Project Staff Report

CONPL 18-001 Bluff Ave. Townhomes

Meeting Date: November 15, 2018

BLUFF AVENUE TOWNHOMES - SKETCH PLAN

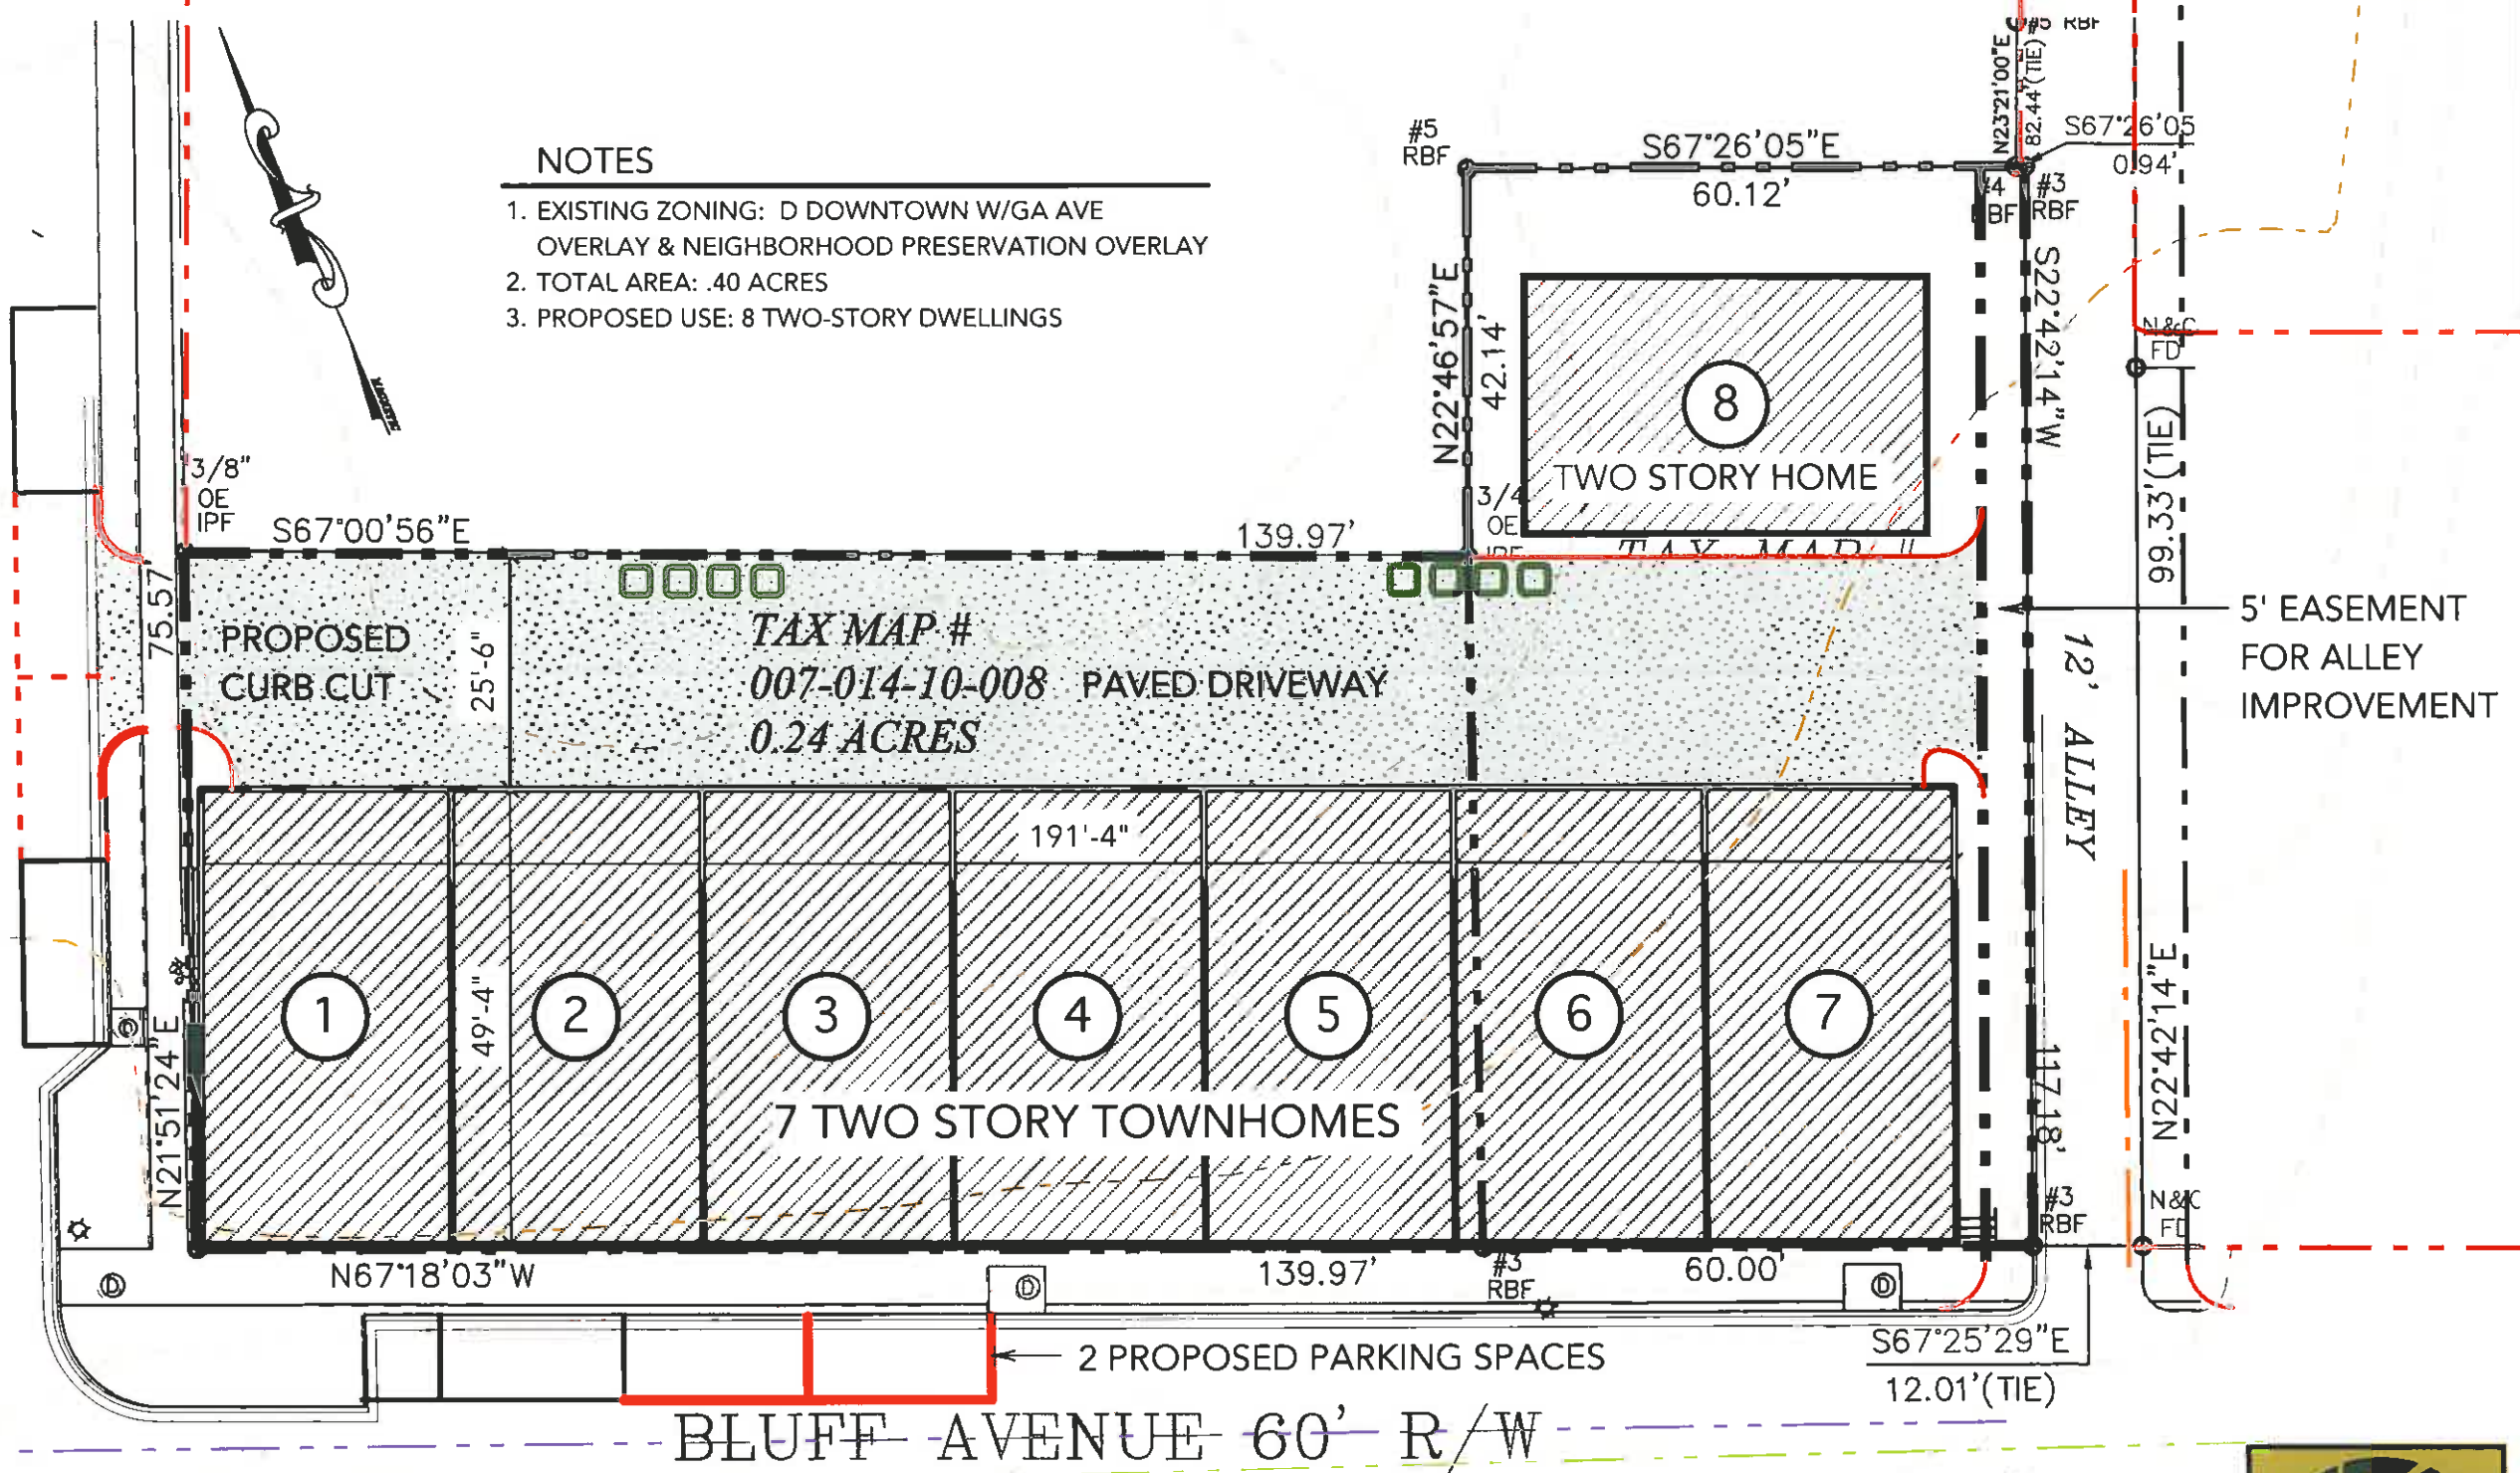
The buildings appear to be shown to meet the front setback, except Building 8, which is 78' from the frontage road. The sides appear to meet setback requirements. Additional comments related to this requirement are included later.

Buildings 1-7 appear to generally meet the setback requirements. It appears Building 8 will need a variance for the setbacks proposed through the Board of Zoning Appeals. Sketch plans do not provide an elevation height at this time.

“The building code has minimum fire separation distances to property lines. The building lines on the two street frontages are right on the property line. The eave will project over the property line (not allowed), the front of the home on Bluff will have doors and windows (The building code doesn’t allow openings within 3 ft of property line). They could rate the West Ave. side with no windows but it would be a stark flat wall which may not pass architectural standards.

Developers commonly use a “zero lot line” with 3-3 or 0-6 setbacks. The fire separation distance is viewed differently regarding the property line when all properties are within the PUD and are all required to abide by whatever covenants are in place. Given that they want to place the buildings on a property line outside their development, I don’t feel like I can view it the same way unless there is something expressed in zoning. 3 ft to the property line on the street frontages would solve this building issue.”

Based on these provisions, it appears the addition of a driveway access to West Avenue would require a variance through the Board of Zoning Appeals.

- *The Georgia Avenue Overlay will generally allow the building footprints shown for Buildings 1-7.*
- *Building 8 will require setback variances through the Board of Zoning Appeals.*
- *The access to West Ave. will require a variance through the Board of Zoning Appeals.*
- *Specific architectural features will be reviewed when more detailed plans are available.*
- *The driveway is currently shown all the way to the property line, which may require a variance to remove/reduce landscaping requirements on site.*

- *The Neighborhood Protection Overlay will generally allow uses shown.*
- *The plan as shown far exceeds the 3,000 sq ft footprint limit.*
- *Roof lines will require additional analysis to review.*
- *The setbacks, particularly the front, will need further analysis to determine. Any variance will be heard by the Board of Zoning Appeals.*
- *Building 8 will likely require setback variances through the Board of Zoning Appeals.*
- *The access to West Ave. will not require a variance.*
- *Specific architectural features will be reviewed when more detailed plans are available.*
- *The driveway is currently shown all the way to the property line, which may require a variance to remove/reduce landscaping requirements on site.*
